SAN FRANCISCO PLANNING DEPARTMENT

Certificate of Appropriateness Executive Summary

Record No.: 2019-021832COA
Project Address: 300 BARTLETT STREET (aka. 3359 24TH STREET)
Landmark No.: 234 (Mission Branch Carnegie Library)
Zoning: P (PUBLIC) Zoning District
55-X Height and Bulk District
Block/Lot: 6515/001
Project Sponsor: Andrew Sohn, San Francisco Public Works
49 South Van Ness Avenue
San Francisco, CA 94103
Staff Contact: Stephanie Cisneros - 415-575-9186
Stephanie.Cisneros@sfgov.org
Recommendation: **Approve with Conditions**

2 STAIR 1 GROUND FLOOR PLAN
1/4" = 1'-0"

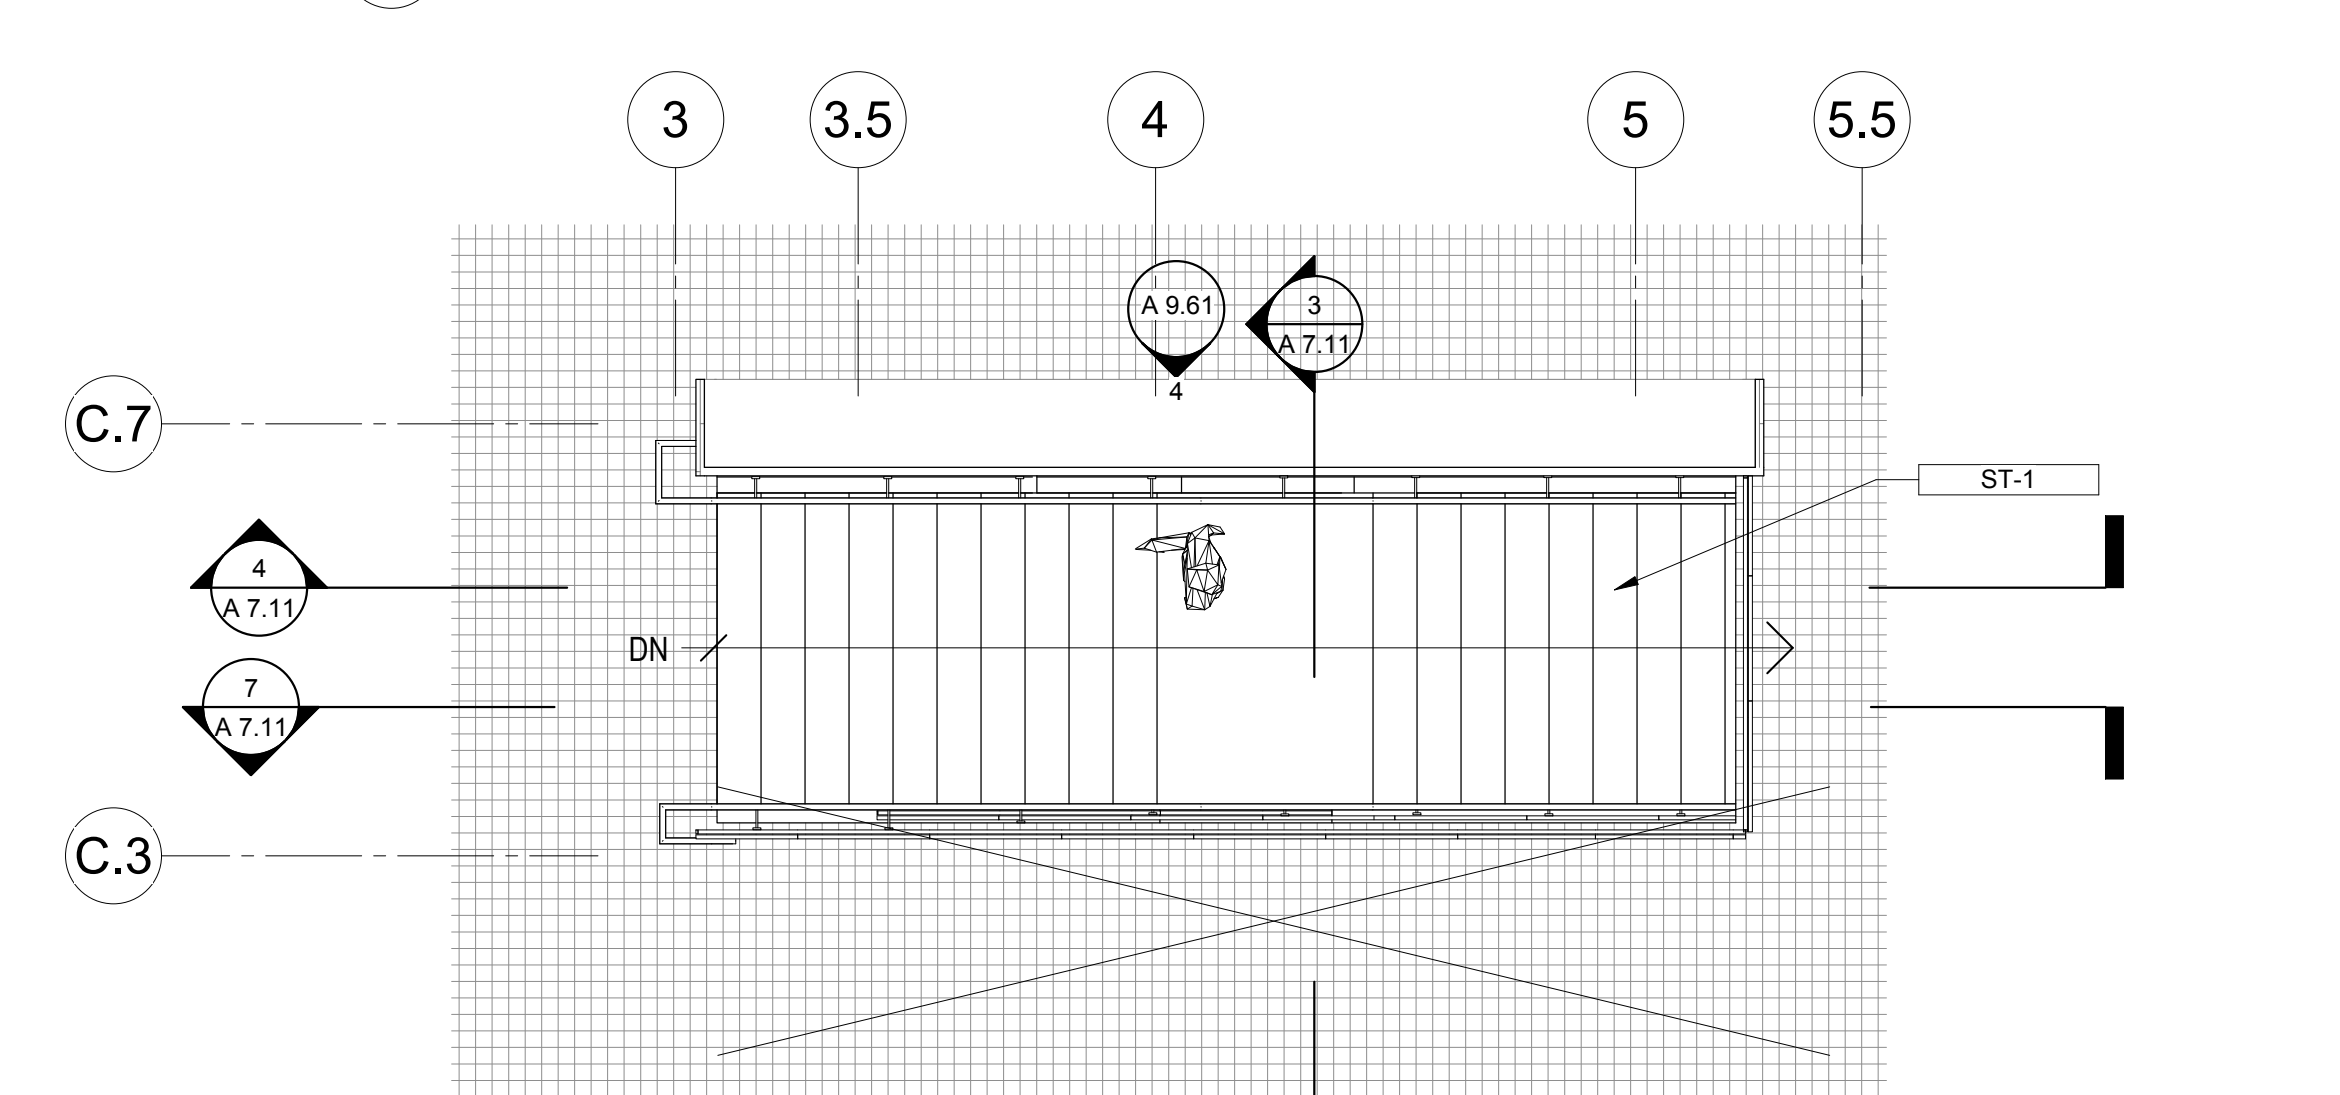
- **Central Stair:** At the April 15, 2020 ARC hearing, the Commissioners commented that the materials of the guardrail at the top of the new central stair should be revised from glass to a material(s) and design that would better correlate with that of the historic stair based on historic documentation. Staff is concerned that the Project Sponsor did not adequately address ARC's comment(s) regarding the materials and design of the central stair railing and recommends that it be further revised to do so.

- Prior to the issuance of a site permit, the Project Sponsor shall revise the fence along Bartlett Street per comment(s) provided by the ARC.
- Prior to the issuance of a site permit, the Project Sponsor shall work with staff on designing a new central stair that is reflective of the historic stair in both materials and design, based on available historic documentation.
- Prior to the issuance of a site permit, the Project Sponsor shall provide a salvage and/or storage plan for exterior materials to be removed to accommodate the new addition.
